RS-15-255

R. E. Ginna Nuclear Power Plant  
Renewed Facility Operating License No. DPR-18  
NRC Docket No. 50-244

Subject: Response to NRC Audit Review Request for Additional Information Regarding  
Fukushima Lessons Learned - Flood Hazard Reevaluation Report

**Response to NRC Audit Review Request for Additional Information Regarding  
Fukushima Lessons Learned - Flood Hazard Reevaluation Report**

Figure 9-10: Combined Effect PMF Time Series Plot for Grid Element 6193 – East of Reactor Containment

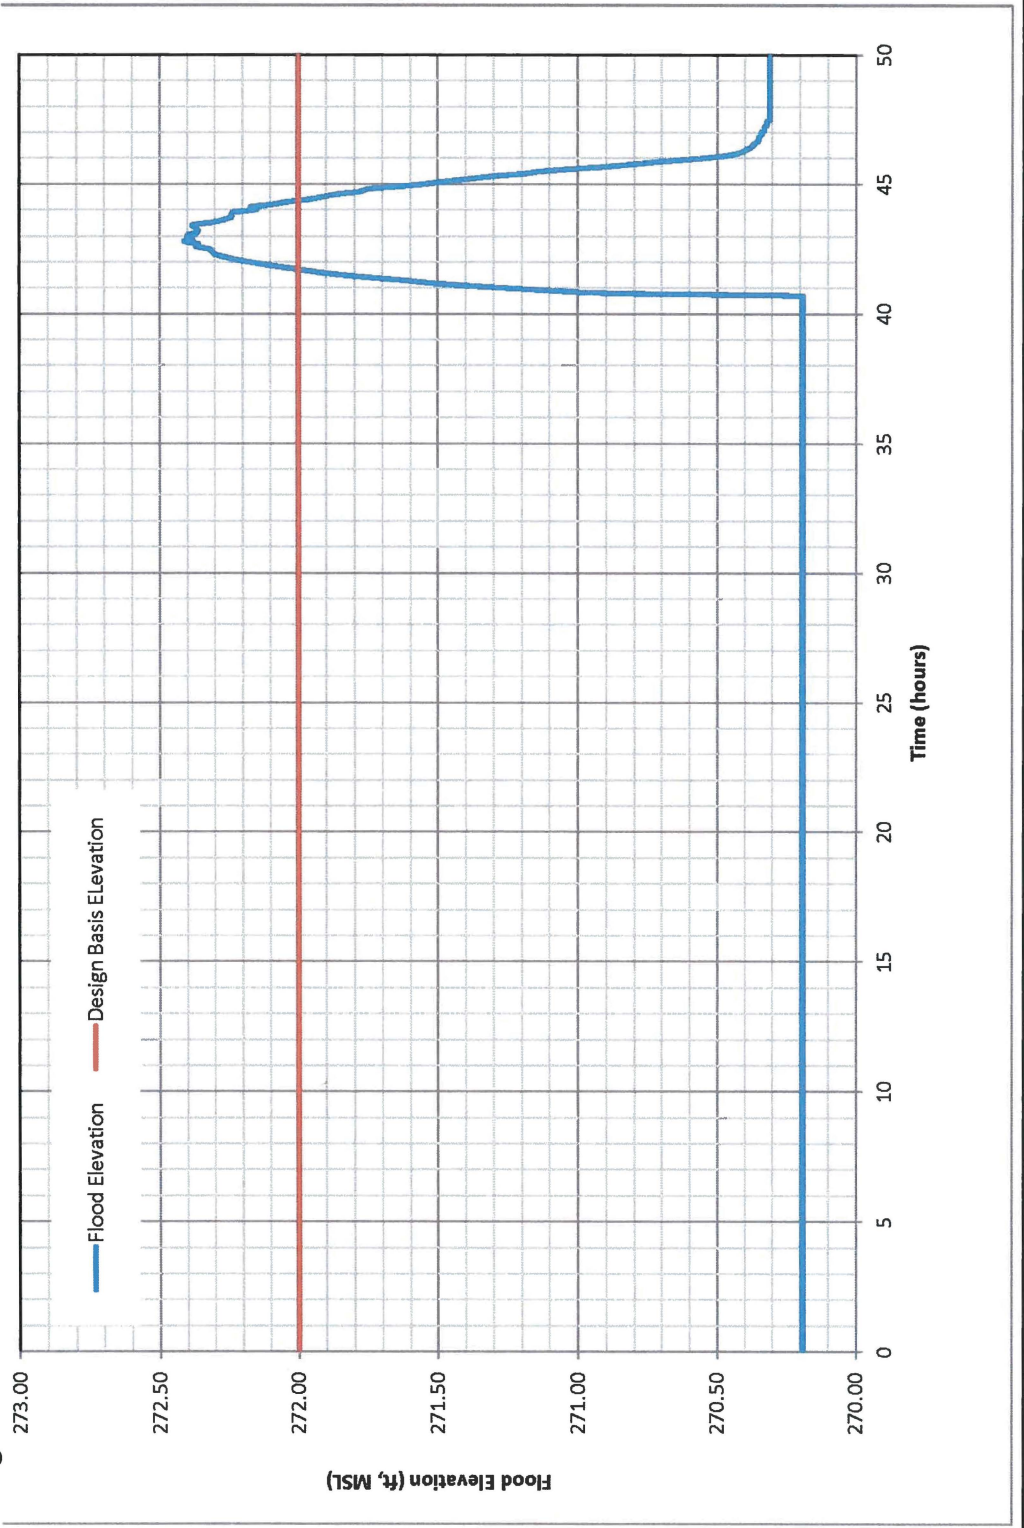
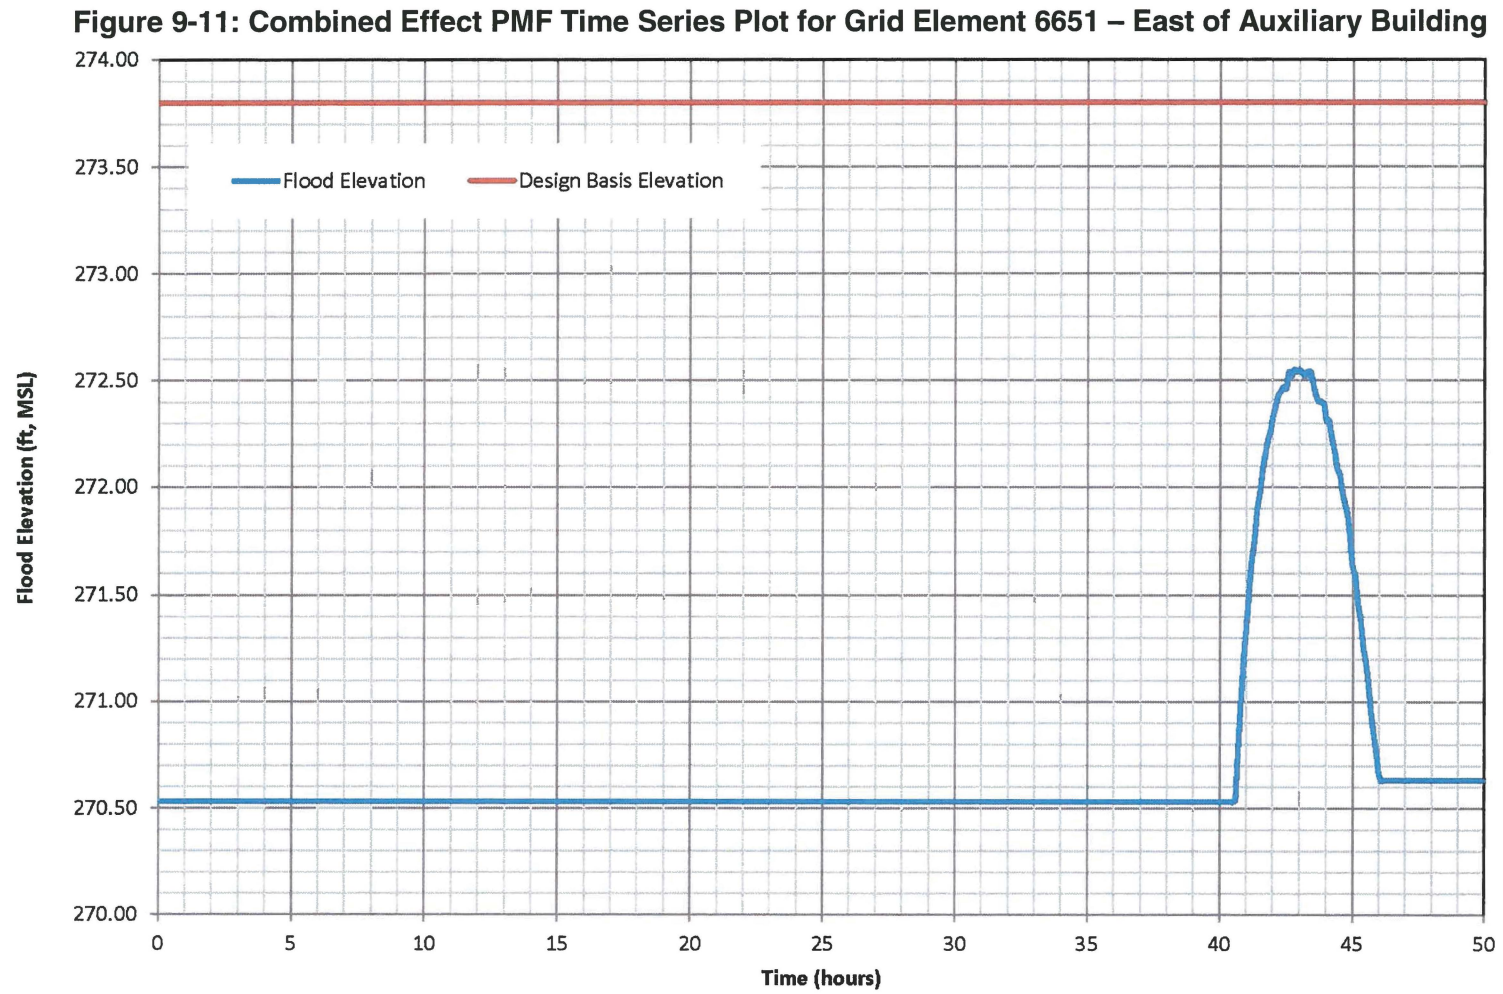
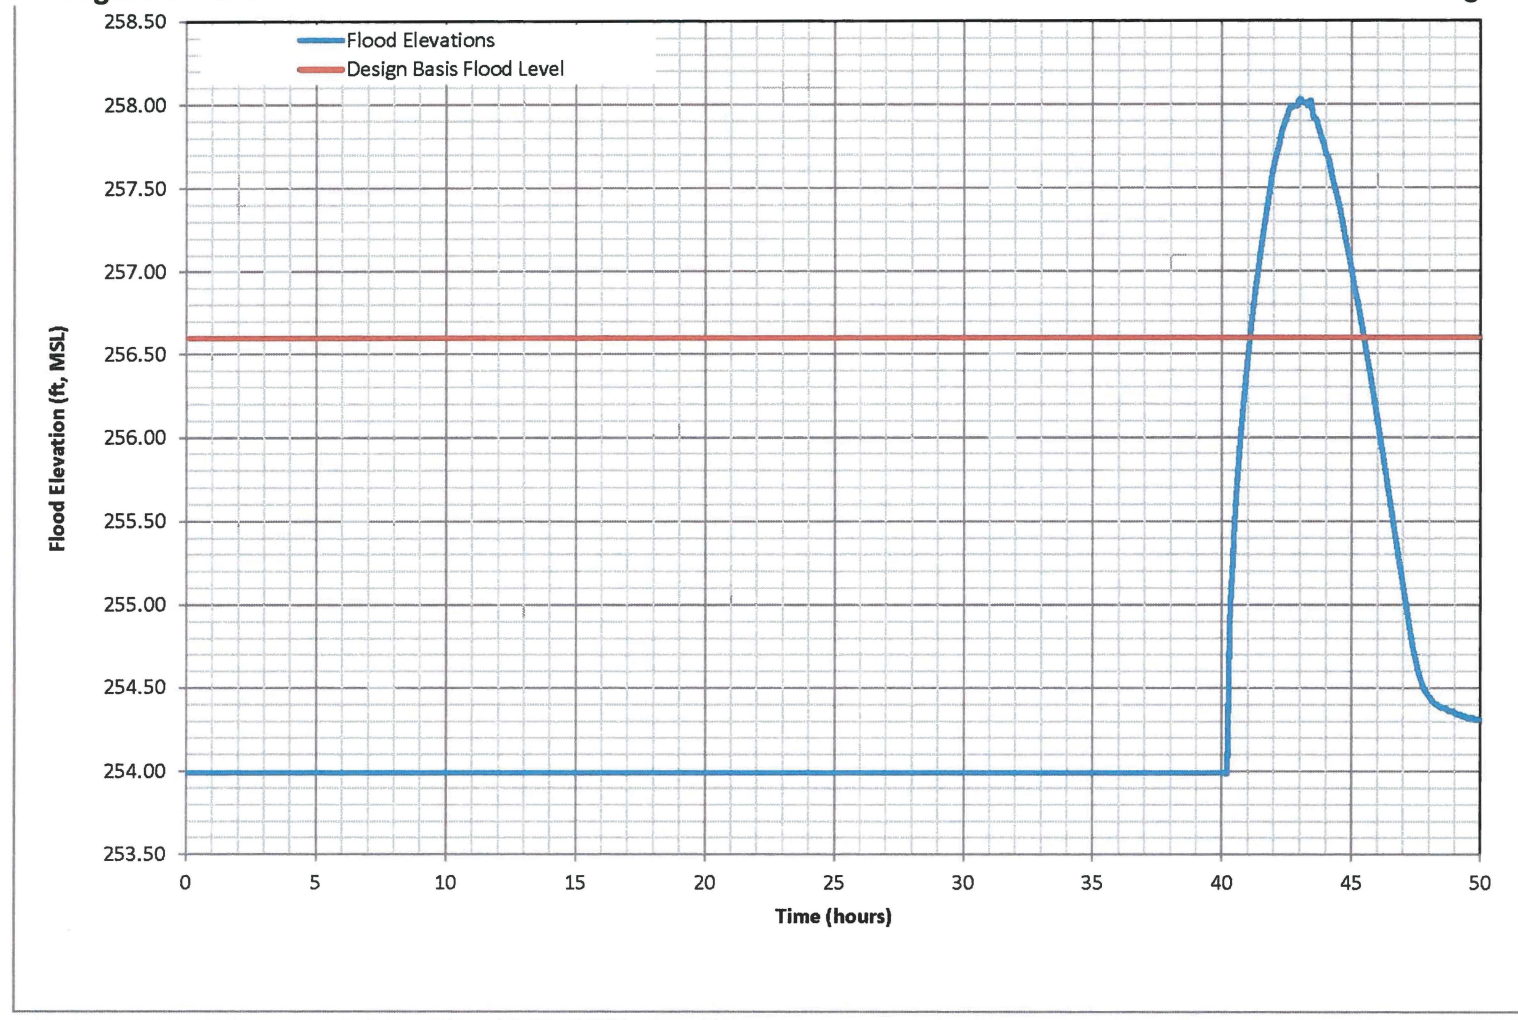
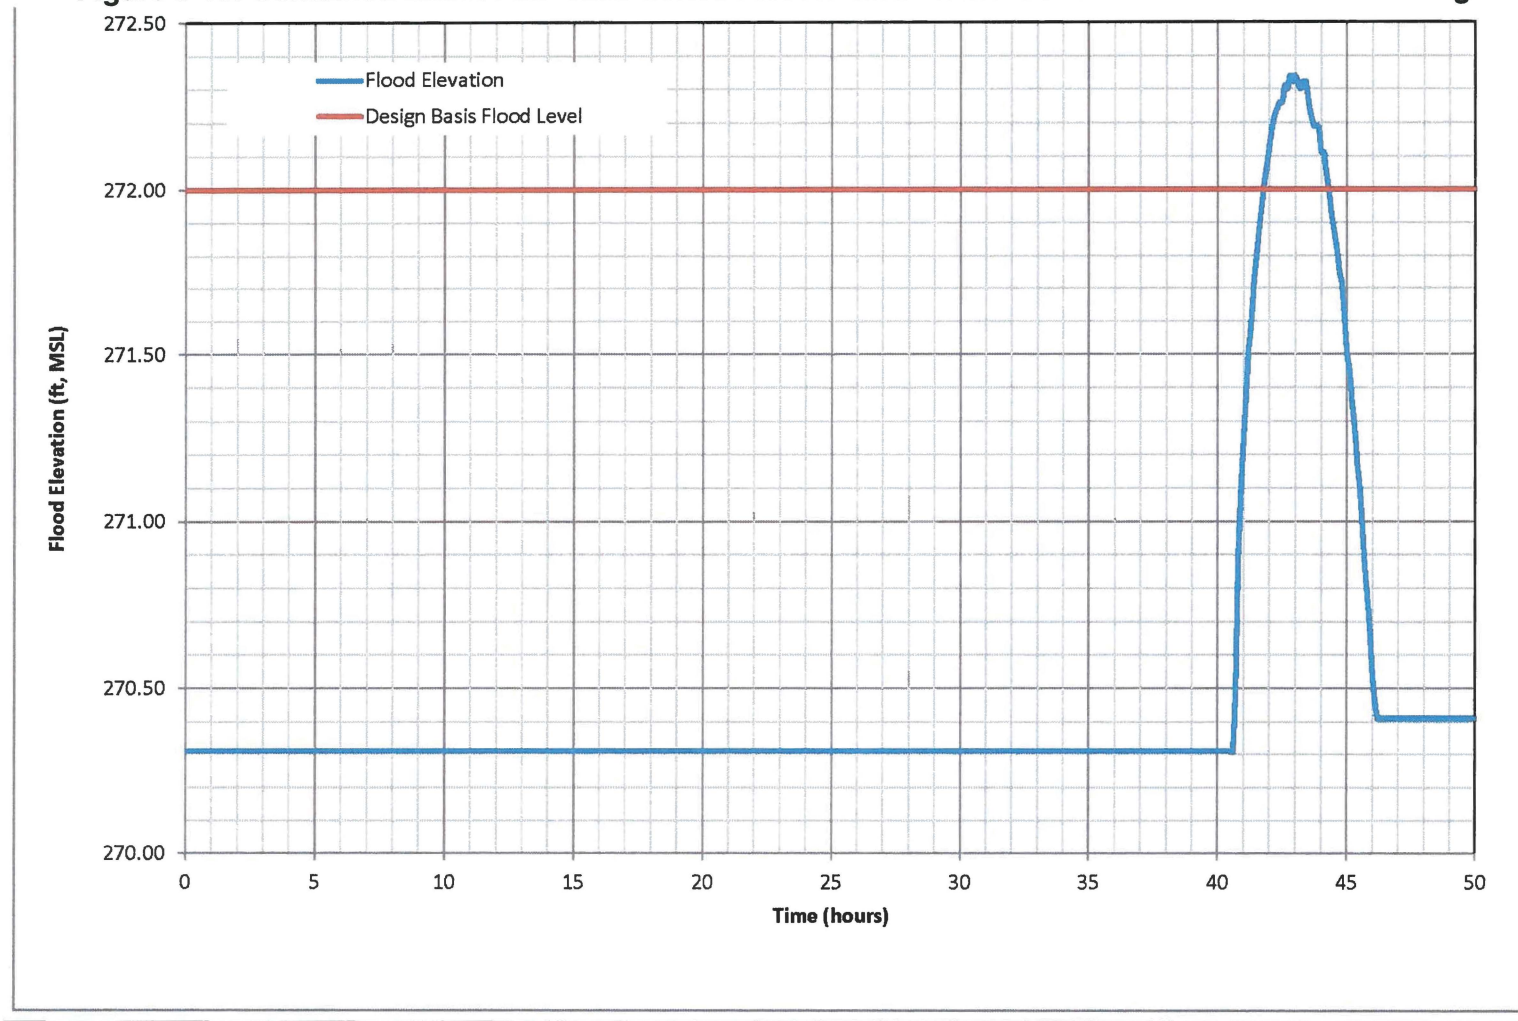
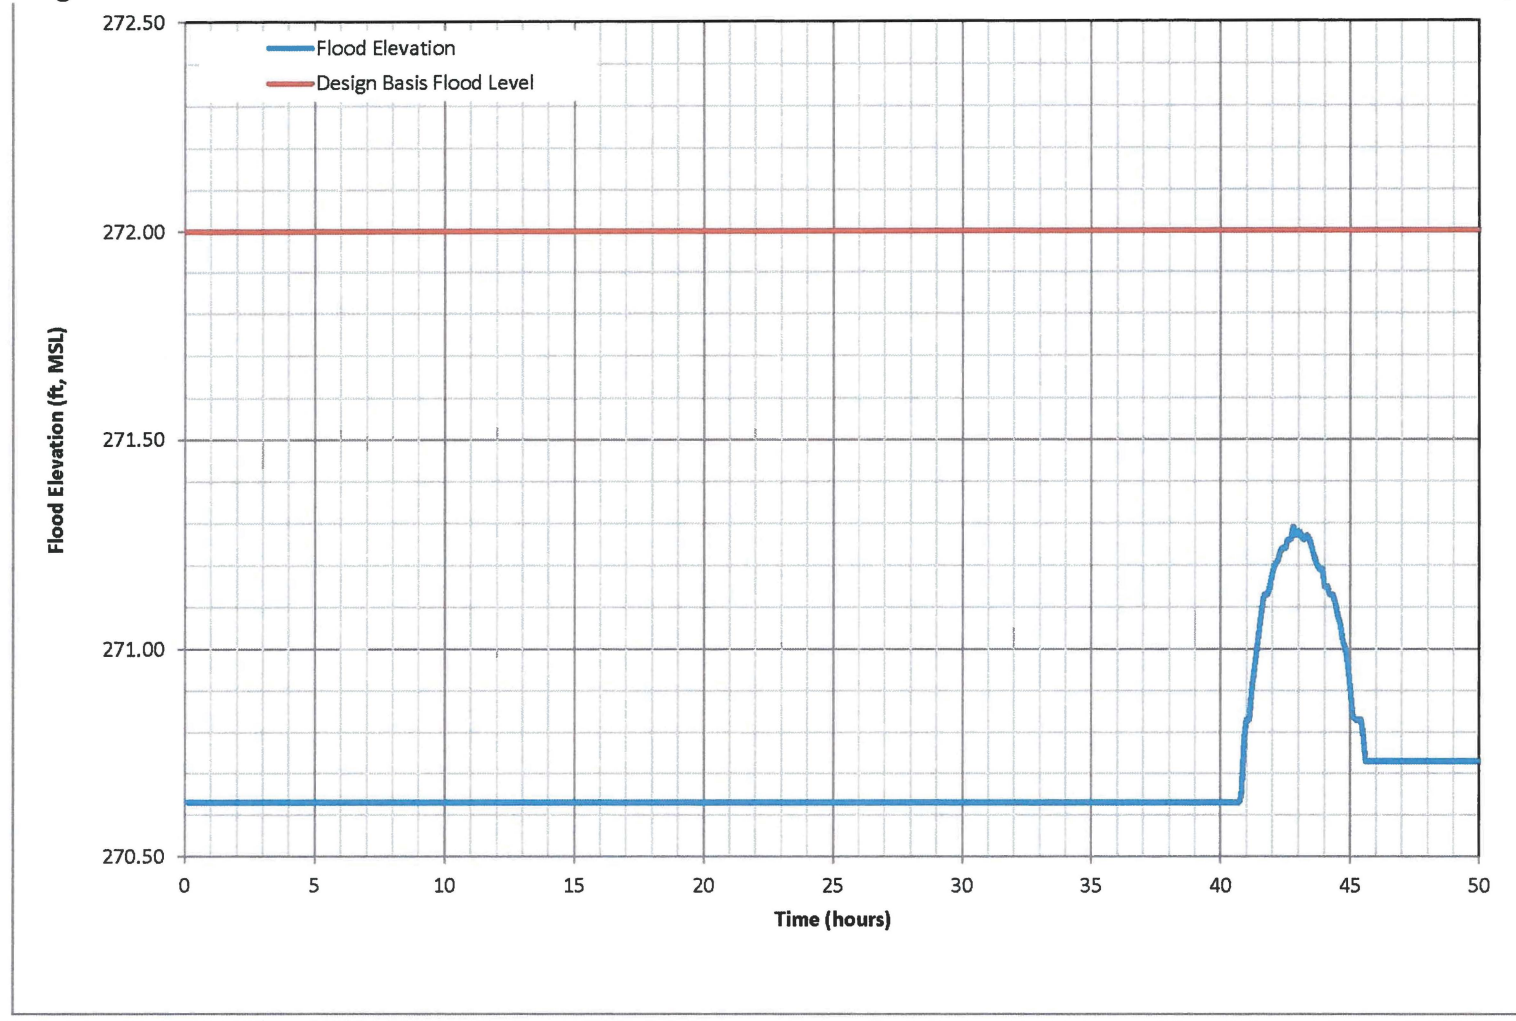
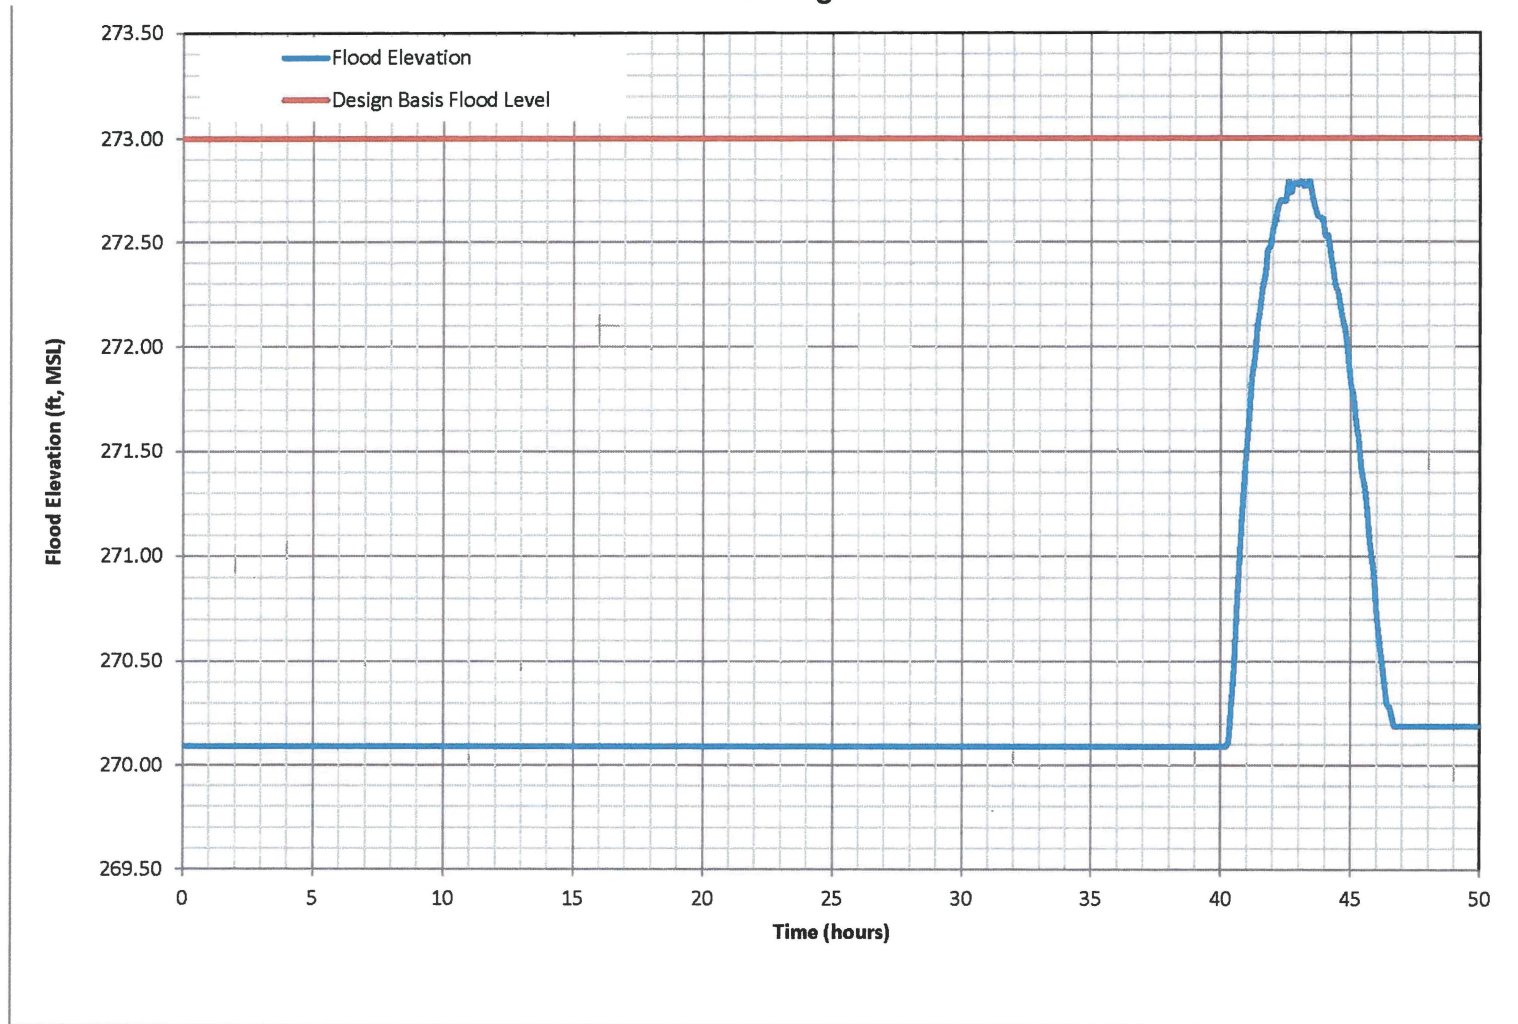
**Request:** *Provide the applicable flood event duration parameters (see definition and Figure 6 of the Guidance for Performing an Integrated Assessment, JLD-ISG-2012-05) associated with mechanisms that trigger an Integrated Assessment using the results of the flood hazard reevaluation. This includes (as applicable) the warning time the site will have to prepare for the event (e.g., the time between notification of an impending flood event and arrival of floodwaters on site) and the period of time the site is inundated for the mechanisms that are not bounded by the current design basis. Provide the basis or source of information for the flood event duration, which may include a description of relevant forecasting methods (e.g., products from local, regional, or national weather forecasting centers) and/or timing information derived from the hazard analysis. The FHRR does state a PMF flood duration (6.5 h) but other parameters are lacking.*

*In Section 3.3 of the FHRR, LIP, flooding on rivers and streams, and two combined-effects flood scenarios were stated to exceed the current licensing basis (which needs to be evaluated/corrected per Information Need #1). The FHRR did not provide sufficiently clear information on all flood duration parameters.*

Time series graphs for the LIP flood mechanism at key locations are provided as Figures 9-1 through 9-9. Time series graphs for the combined effect PMF flood mechanism at key locations are provided as Figures 9-10 through 9-19.

The FHRR indicates flood protection measures described in the FSAR trigger on flood levels at Driveway Bridge. Based on detailed time-series data for the combined effect flood scenario (bounding Deer Creek flooding scenario), there is a 35+ hour delay between the triggering flood levels at Driveway Bridge and flood levels above grade near plant structures.
